ADDENDUM NO. 03

Three Rivers Community Schools District Signage 700 Sixth Avenue Kalamazoo, MI 49093

OWNER THREE RIVERS COMMUNITY SCHOOLS **PROJECT** DISTRICT SIGNAGE PACKAGE A/E Project 5-6405 **ADDENDUM 003 PURPOSE** THIS ADDENDUM SHALL FORM PART OF THE BIDDING DOCUMENTS. CHANGES, ADDITIONS, CLARIFICATIONS OR DELETIONS HEREIN SUPERSEDE THE DRAWINGS AND SPECIFICATIONS. BIDDERS SHALL INCLUDE ON THE PROPOSAL FORM ACKNOWLEDGEMENT OF THE RECEIPT OF THIS ADDENDUM. **ATTACHMENTS New Specifications: None** Reissued Specifications: 10 14 26 New Sheets: C2.06 Reissued Sheets: G0.00, G2.01, C2.01, C2.02, C2.03, C2.04, C2.05 ARCHITECT-ENGINEER **GMB** www.gmb.com 616.796.0200 **CONSTRUCTION MANAGER** THE SKILLMAN CORPORATION www.skillman.com 269.350.5757

ALL RIGHTS RESERVED DEMOLITION AND SITE ELEMENTARY (ADDED ADD. 003)

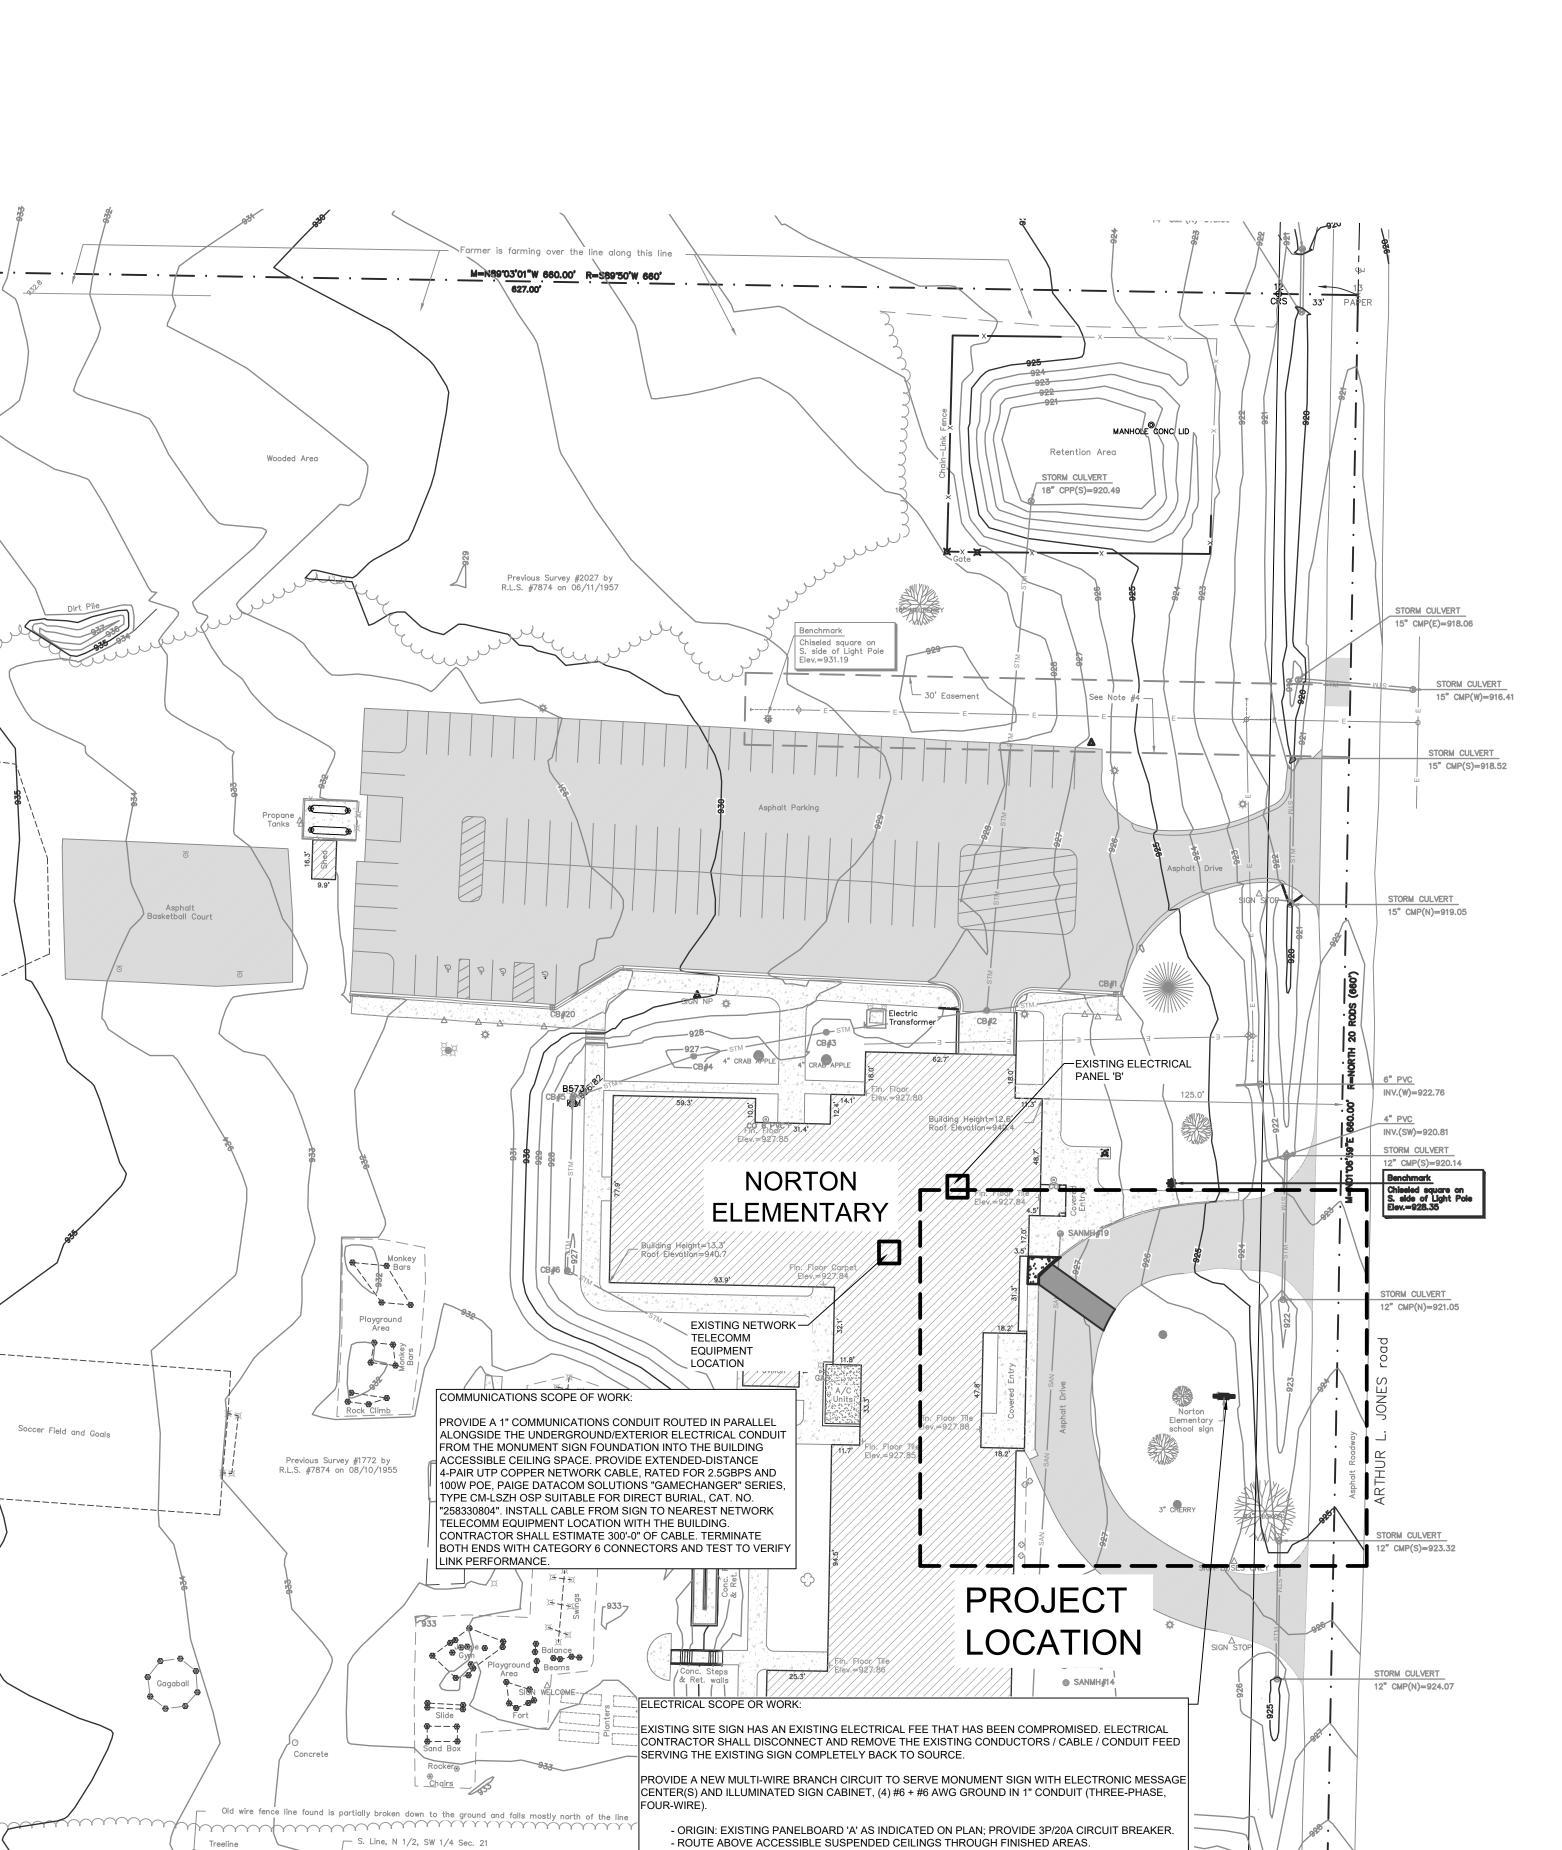
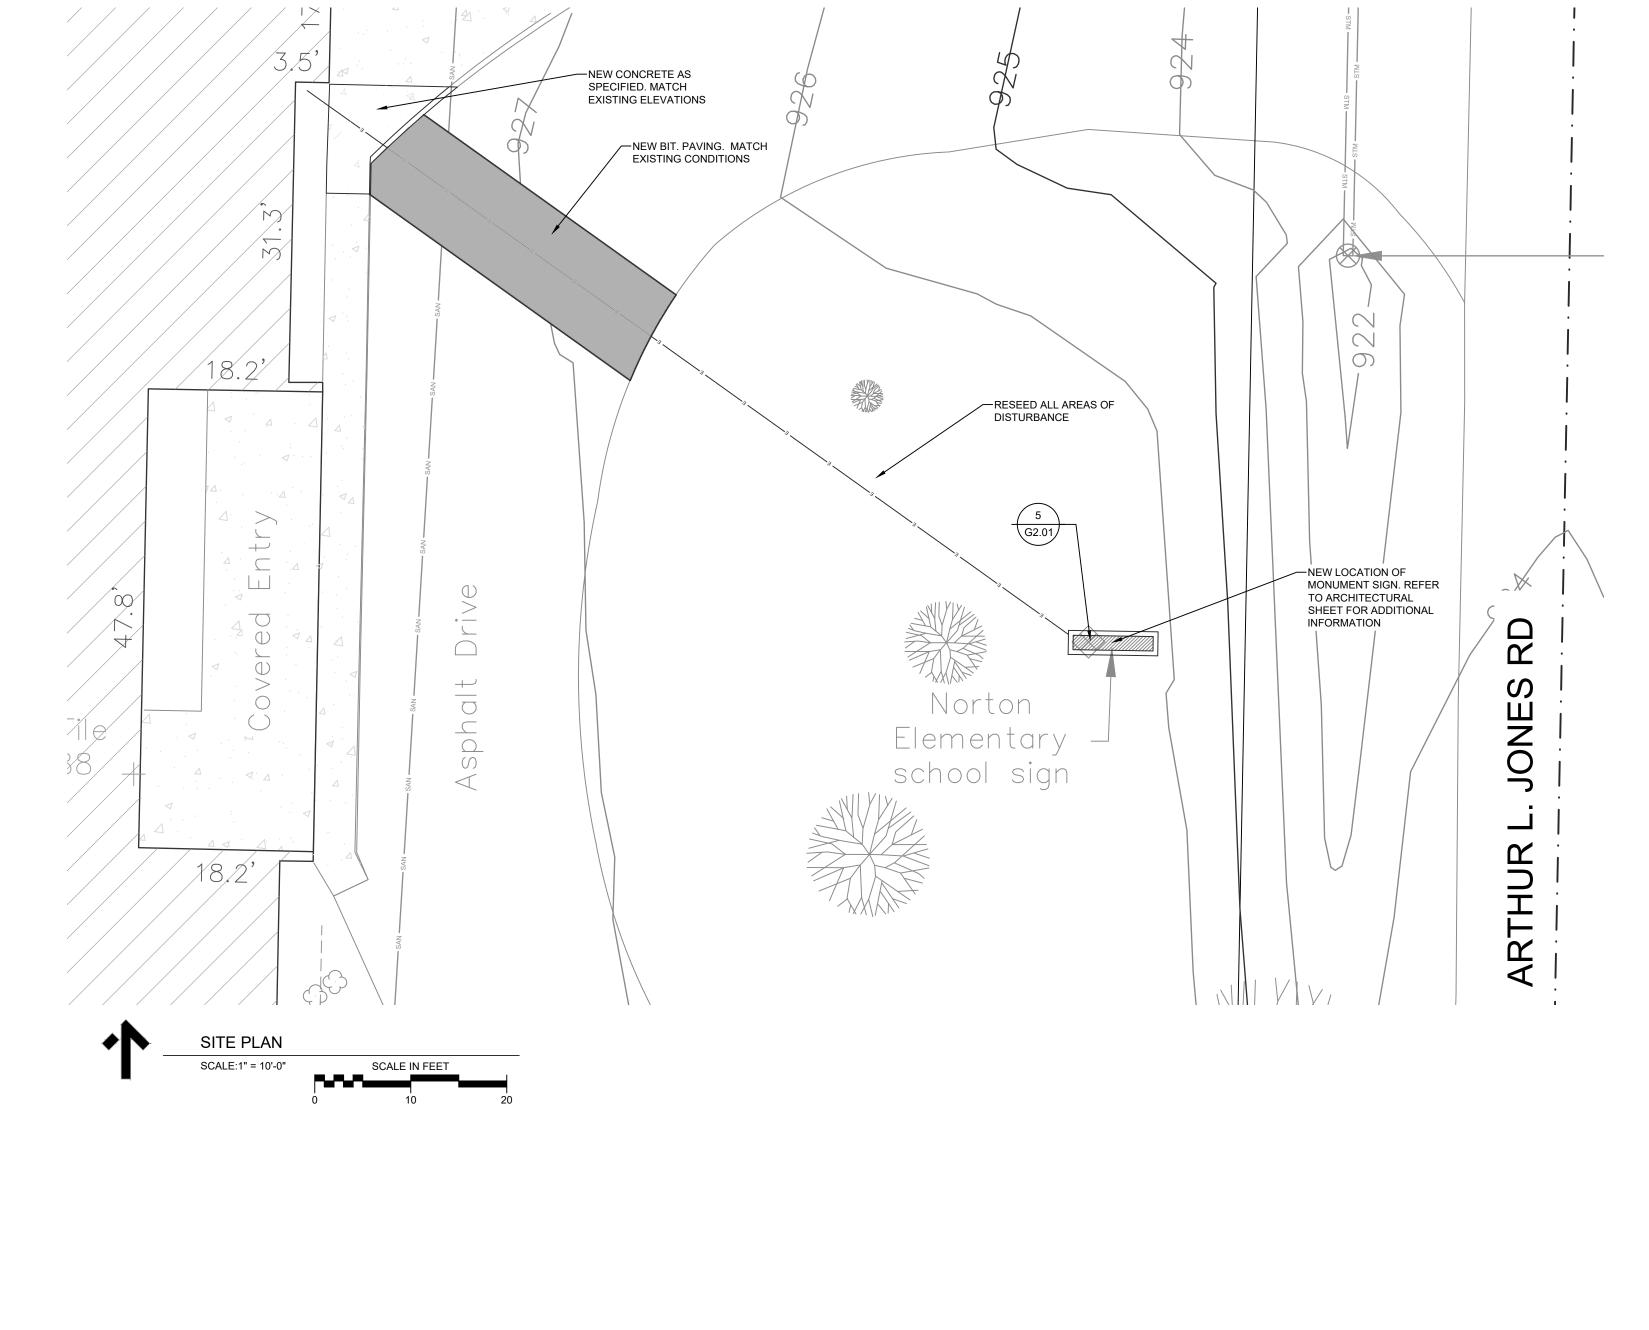
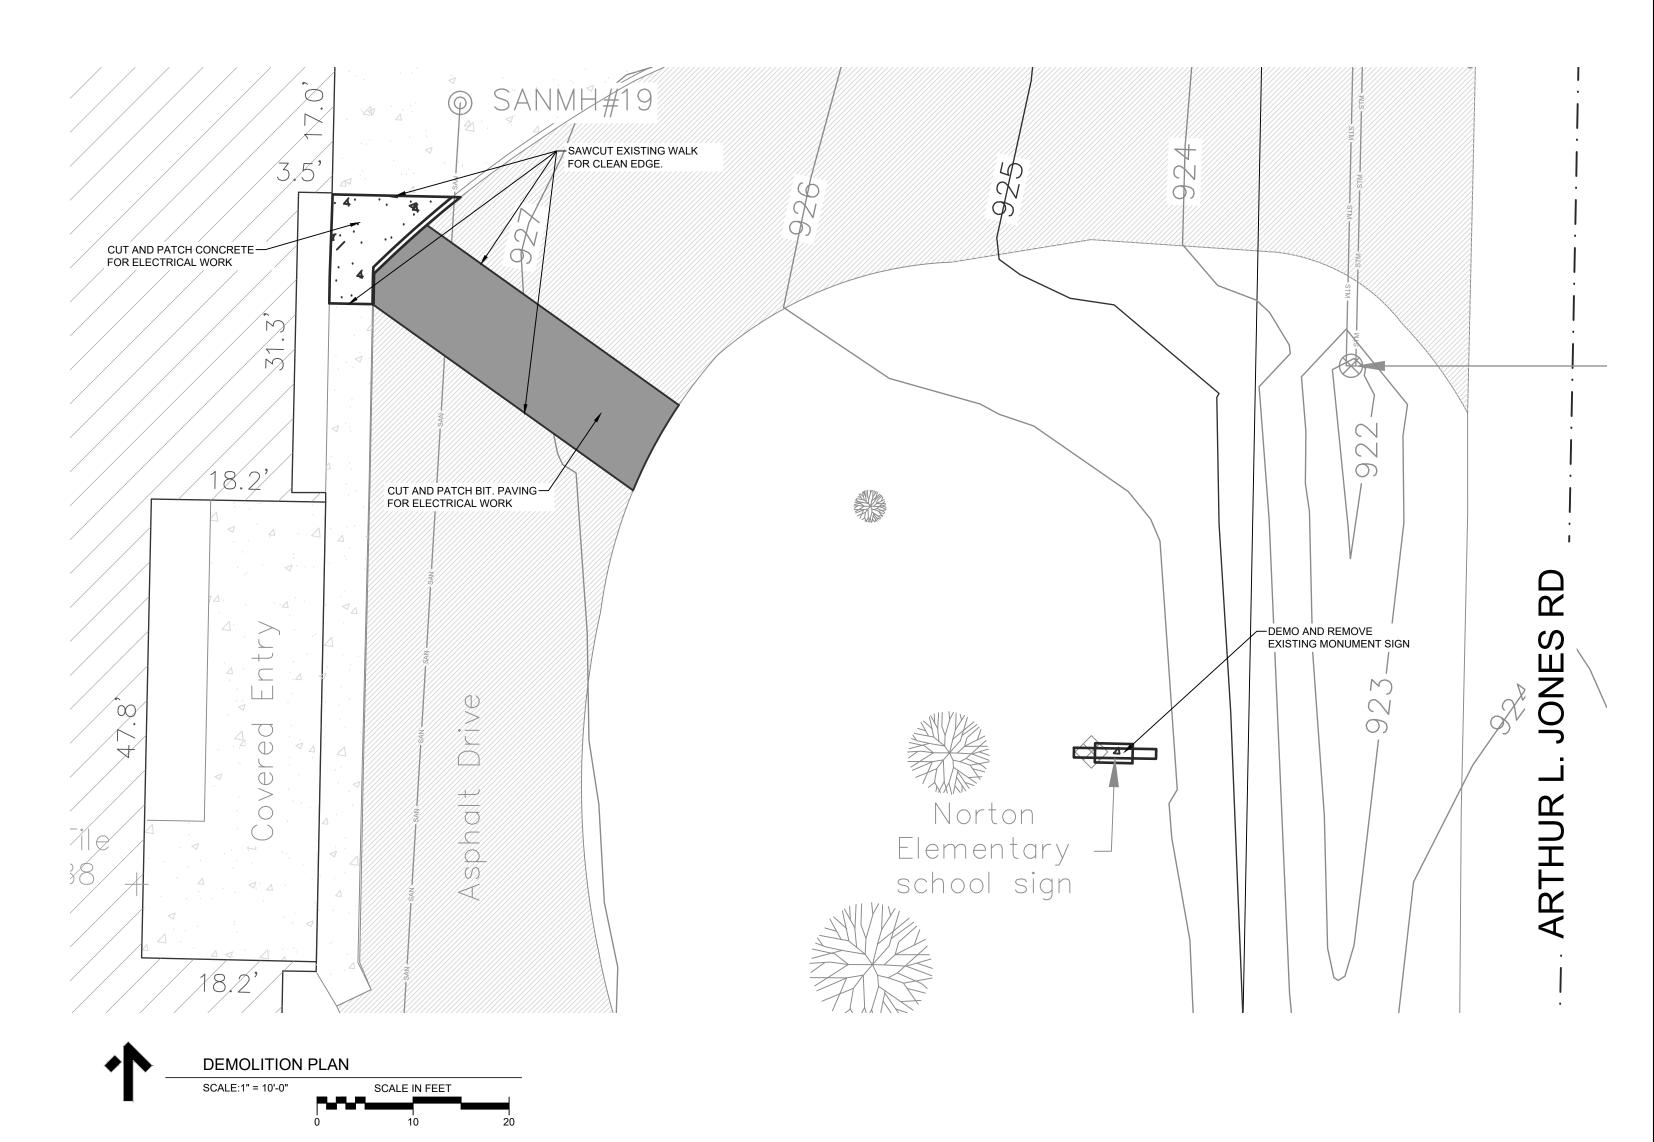
ITEM NO. 9 SHEET C2.06 – DEMOLITION AND SITE PLAN AT NORTON ELEMENTARY (NEW)

Refer to new sheet for work associated with new monument sign, electrical work and related site work.

- STUB OUT OF BUILDING AT CEILING SPACE, TRANSITION WITH CONDUIT BODY AND ROUTE

- STUB UP WITHIN CENTER AREA OF NEW SIGN FOUNDATION PER SIGN MANUFACTURER'S

- PROVIDE A NEMA 3R 3-POLE HEAVY DUTY SAFETY SWITCH (NOT FUSIBLE) FOR DISCONNECTING MEANS; MOUNT TO THE END OF THE SIGN NEAREST THE BUILDING AND WIRE BRANCH CIRCUIT

- CONNECT ALL LOADS 120VAC LINE-TO-NEUTRAL ACROSS THE MULTI-WIRE BRANCH CIRCUIT --

MESSAGE CENTER #1 (PHASE A), MESSAGE CENTER #2 (PHASE B), ILLUMINATED SIGN CABINET

- PROVIDE LOCAL GROUNDING ELECTRODE PER SPECIFICATION AT SIGN, BOND ELECTRODE AND
